| Subject | Briefing Note to Sydney North Planning Panel |
| Property | Nos. 43-47 Kenneth Street, Longueville |
| Description of Proposal | Alterations and additions to an existing private hospital |
| Council/Panel Application No. | DA72/2023 / PPSSNH-405 |

Figure 9 – Rear Lorna Leigh Lane West Elevation

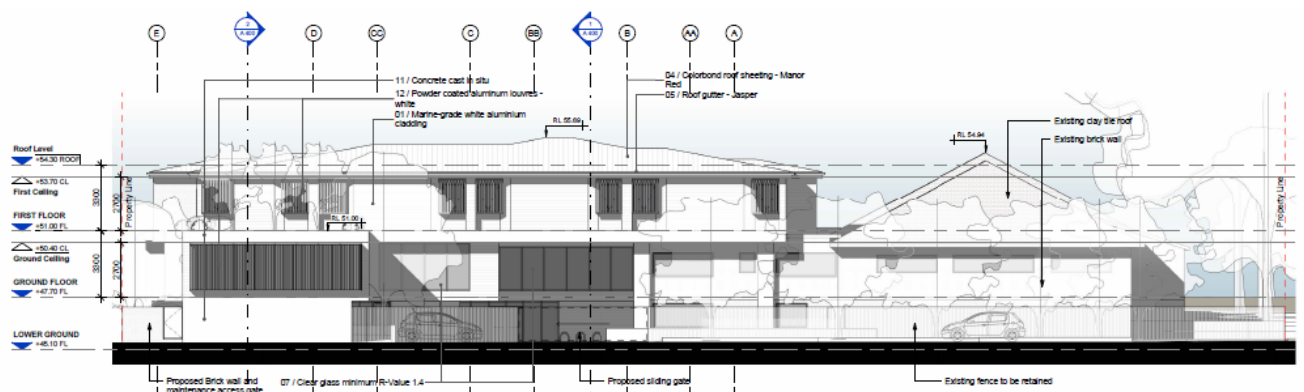
It is considered that the proposed excavation to extend the minor portion of the existing lower-level ground floor area and the new works would create or introduce a new three-storey component to the existing facility to the rear lane/northern boundary and to the adjoining dwellings (see Figure 9 above). This component of the proposal would be contrary to the predominant single/two storey character of the locality and laneway. The proposal breaches Part 1.6(d) which restricts excavation to a maximum of 1m and to Part 1.7.1(e) Height which restricts developments to a maximum of two storeys on relatively flat sites.

Figure 10 – FSR Map Indicating FSR Ratio Split on the Subject Site (Corner of Kenneth St and Christina St)

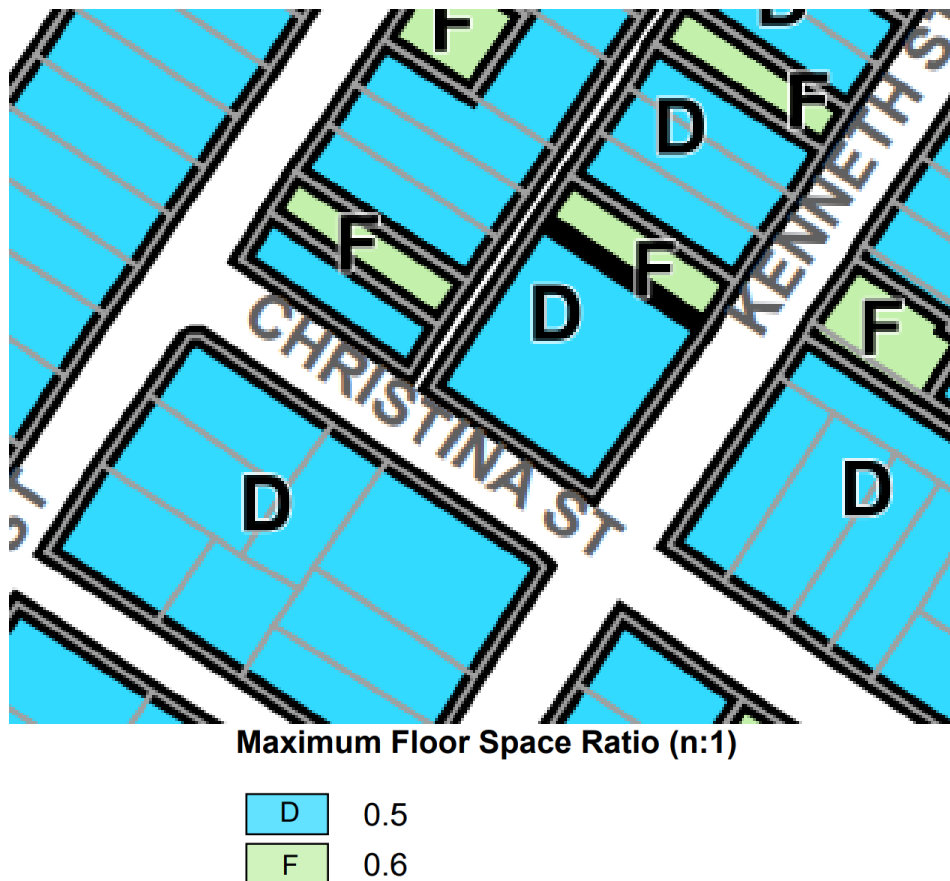
The proposed development is not compliant with the relevant numerical **0.5:1** and **0.6:1** FSR Development Standards of Lane Cove LEP 2009 affecting the subject site by a maximum of **80.5%**.

Accordingly, in relation to the component of the development located on the portion of the site having a maximum prescribed FSR of 0.5:1 (1045.15m²) the development proposes 1886.6m² GFA representing an FSR of 0.9:1. This exceeds the standard by 841.45m² or 80.5%. In relation to the component of the development located on the portion of the site having a maximum prescribed FSR of 0.6:1 (334.44m²) the development proposes 554.8m² GFA representing an FSR of 1:1. This exceeds the standard by 220.36m² or 65.8%.

The proposed substantial non-compliances are unreasonable and unnecessary in this instance. The submitted Clause 4.6 written submission is not supported. The proposed bulk and scale of the proposal would not be compatible with the existing low density residential character of the immediate Longueville locality. It is considered that the proposed FSR would be far too excessive which would indicate that the existing facility is at its maximum bulk/scale which had been already appropriately established.

The proposed large variation is not supported by Council due to the excessive bulk/scale proposed on a site located within a low-density residential locality and would be contrary to the relevant LCLEP aims, zone and FSR objectives.

Figure 12 – Proposed Increase in Scale of the Hospital Facility with Reduced Building Setbacks and Landscaped/Garden Setting

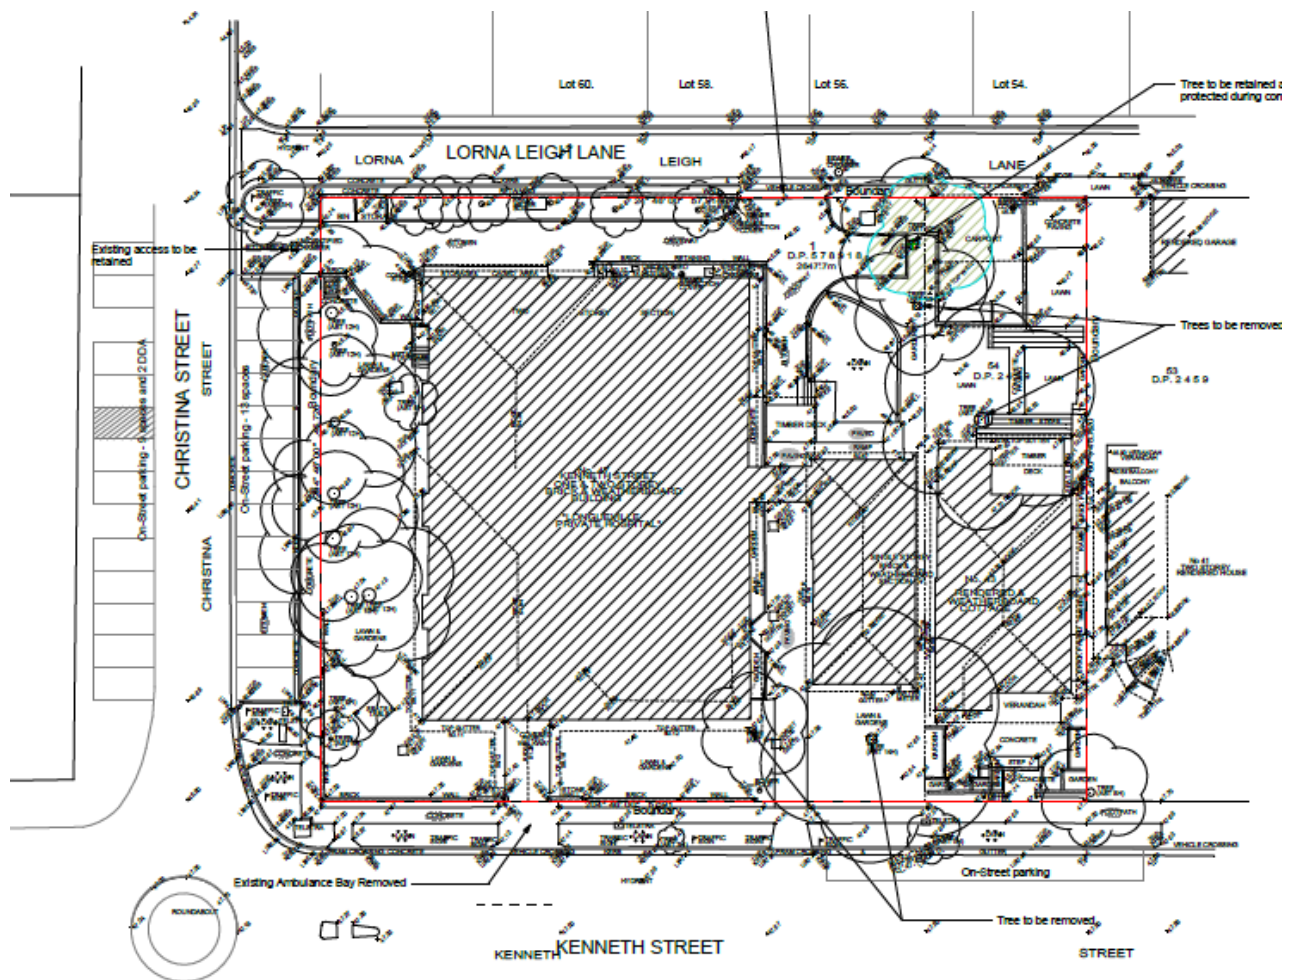
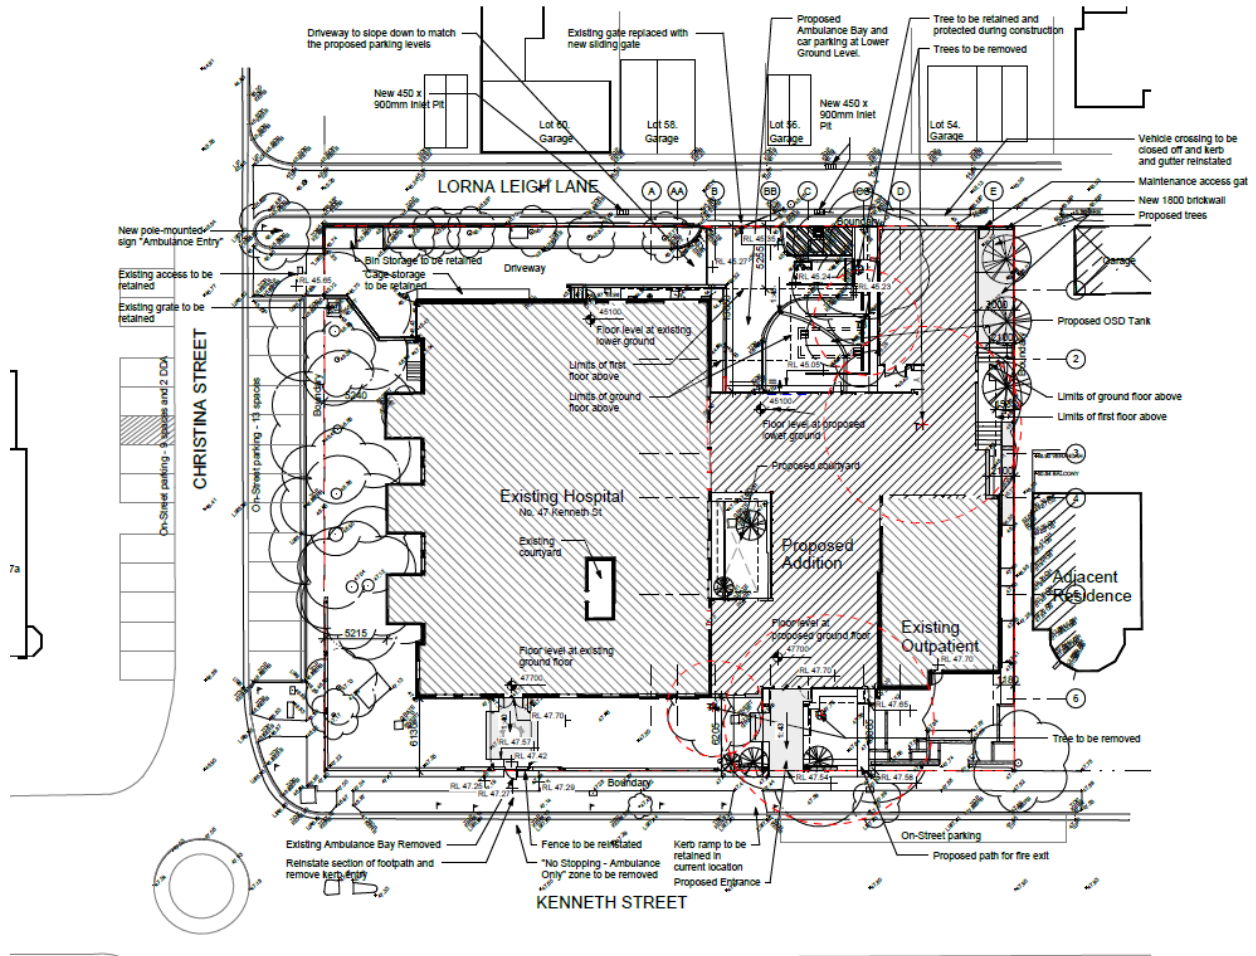
The proposed built form would have significant adverse visual impacts onto adjoining and surrounding residential properties to the north and west of the subject site.

There would be a significant adverse impact on the immediate property to the north due to the extent of the proposed works along the entire northern boundary towards the rear lane at the northwest corner of the site. This is primarily due to the substantial non-compliance with the required rear building setbacks under Lane Cove Development Control Plan (LCDCP) Part C – Residential Development Part 1.3.4 – Rear setbacks. The proposed rear setbacks are not supported as it would not be consistent with other rear setbacks in the locality and with the existing rear setback of the adjoining dwelling at No. 41 Kenneth Street.
